**CORRESPONDENCE COVER SHEET  
WASTE PERMITS DIVISION  
TEXAS COMMISSION ON ENVIRONMENTAL QUALITY**

Date: April 24, 2026  
 Facility Name: Northwest Transfer Station  
 Permit or Registration No.: 40348

Subject: **NOD 3** Response Tracking No. 32527669  
 Northwest Transfer Station MSW Type V Registration Application No. 40348  
 14421 Sommermeyer Street, Houston, Harris County, Texas 77041

**NOD 3 and Responses**

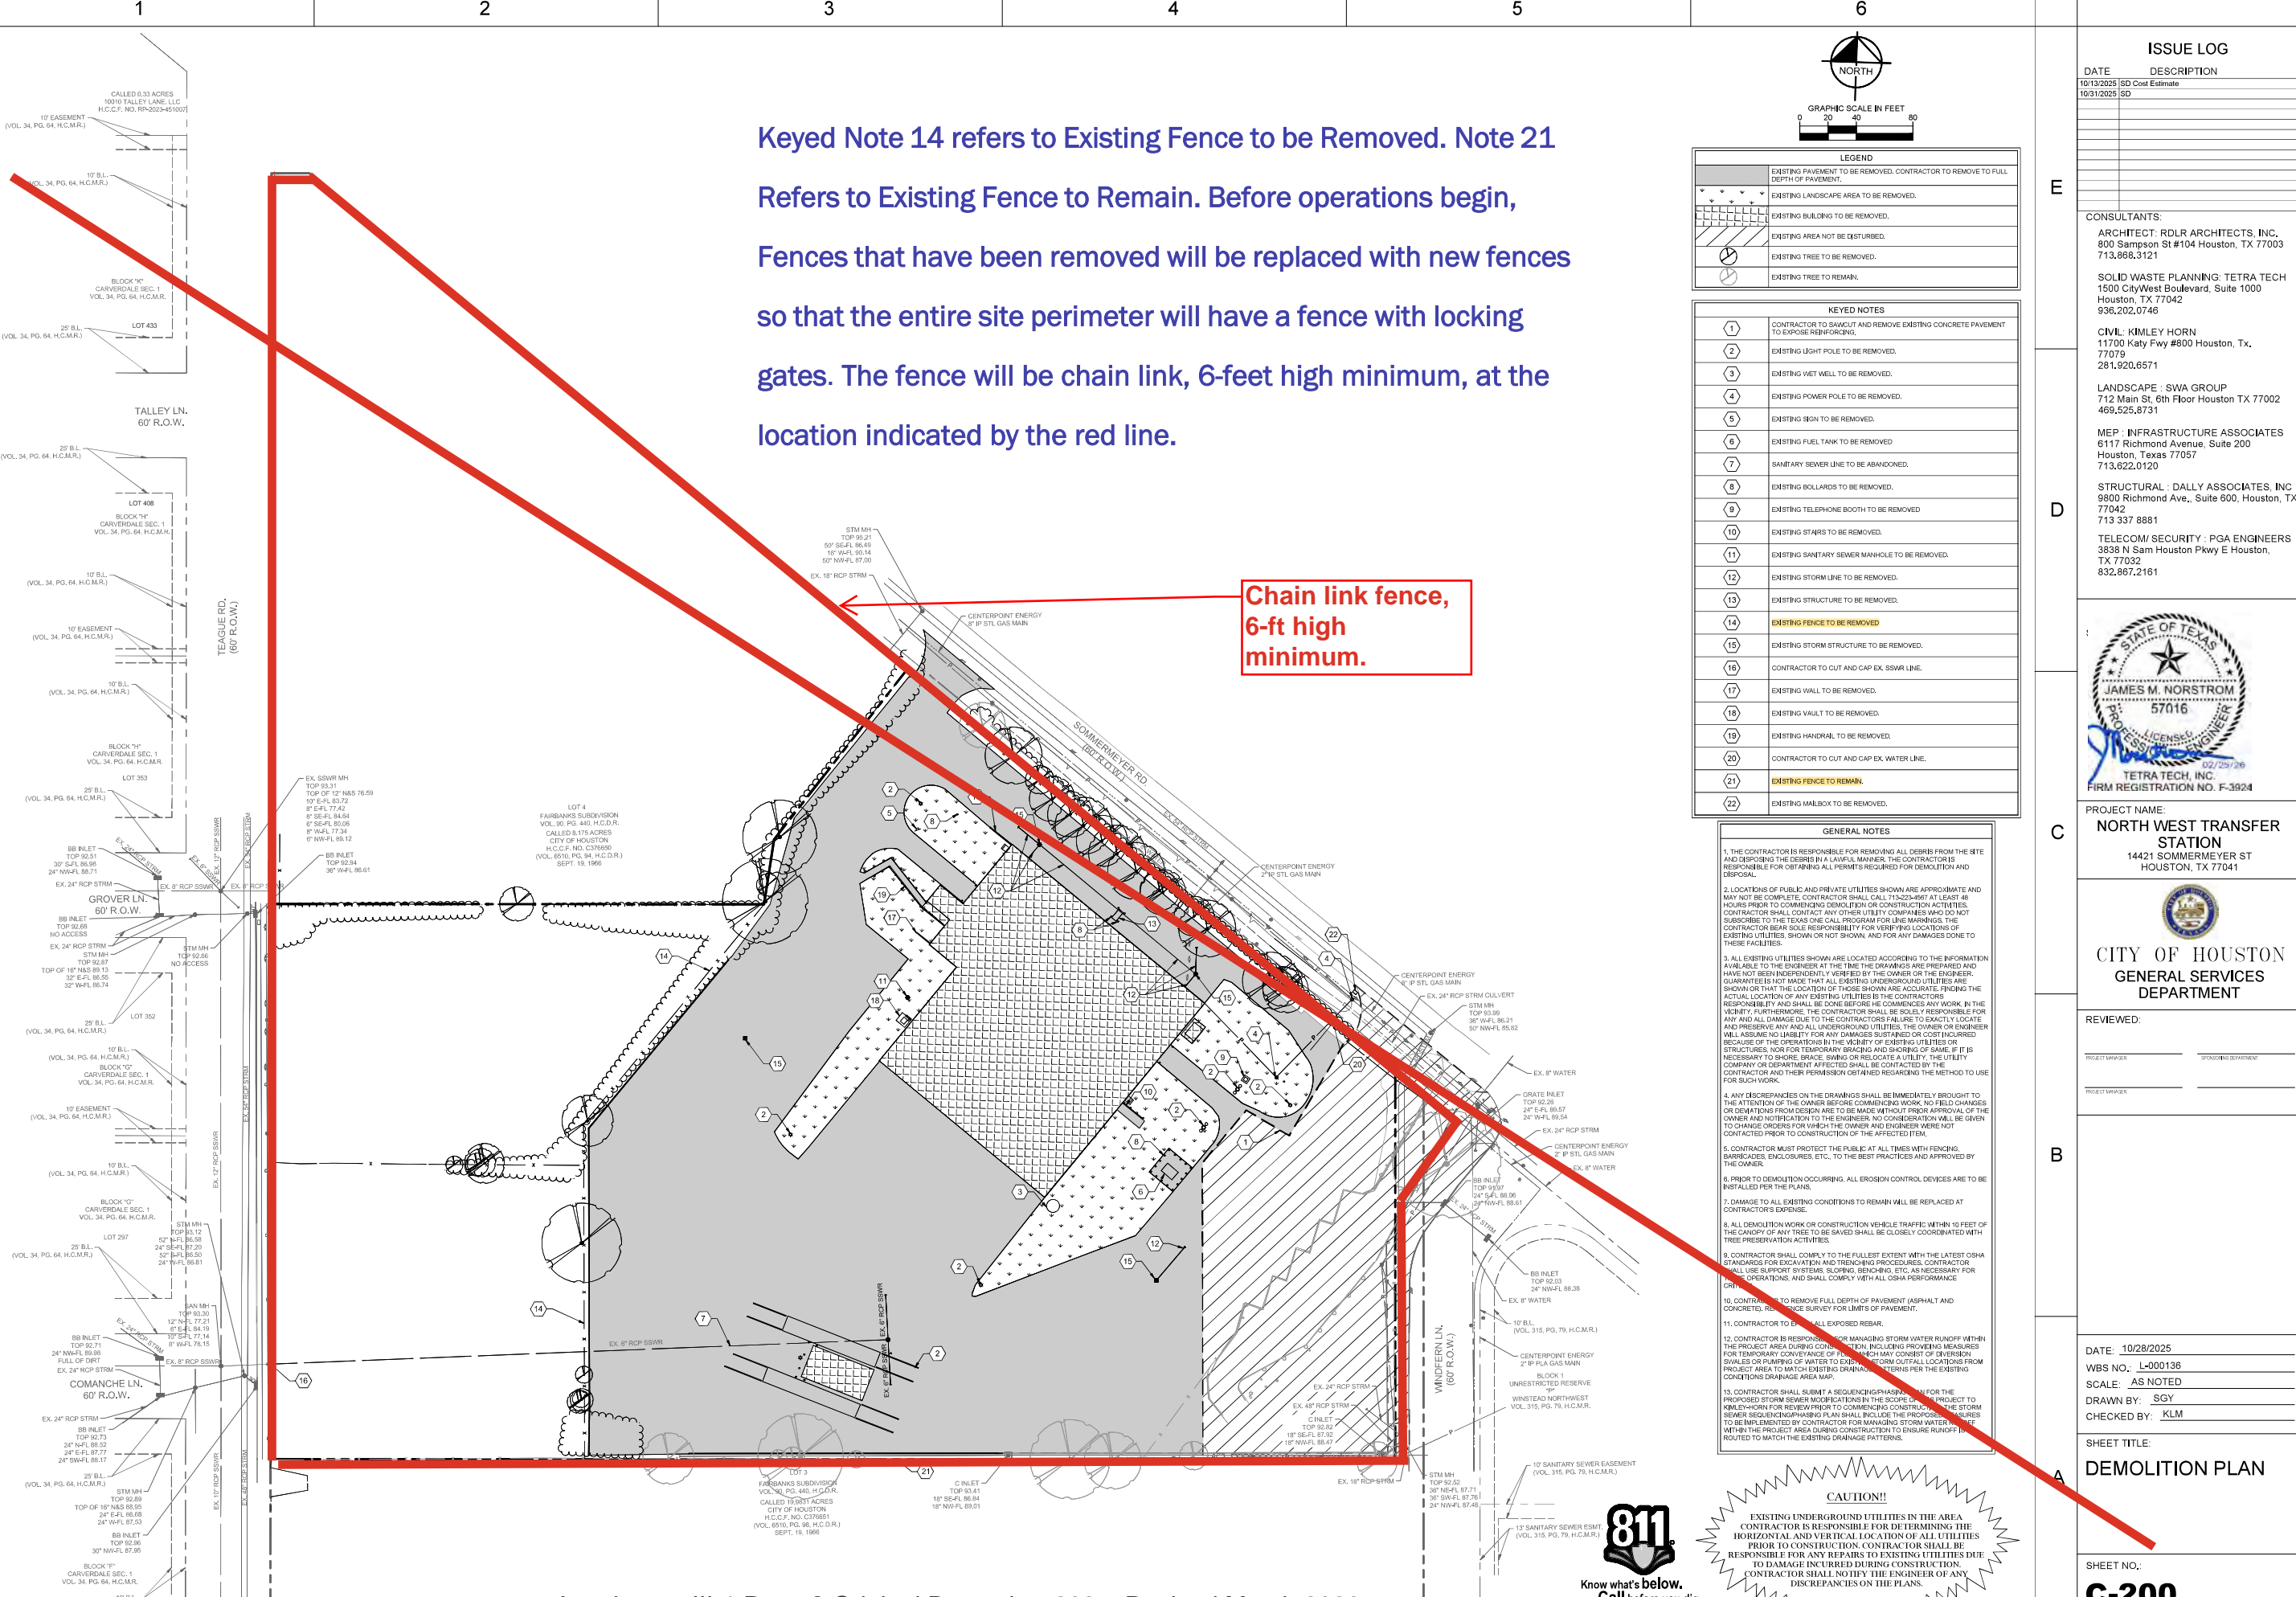
Keyed Note 14 refers to Existing Fence to be Removed. Note 21 Refers to Existing Fence to Remain. Before operations begin, Fences that have been removed will be replaced with new fences so that the entire site perimeter will have a fence with locking gates. The fence will be chain link, 6-feet high minimum, at the location indicated by the red line.
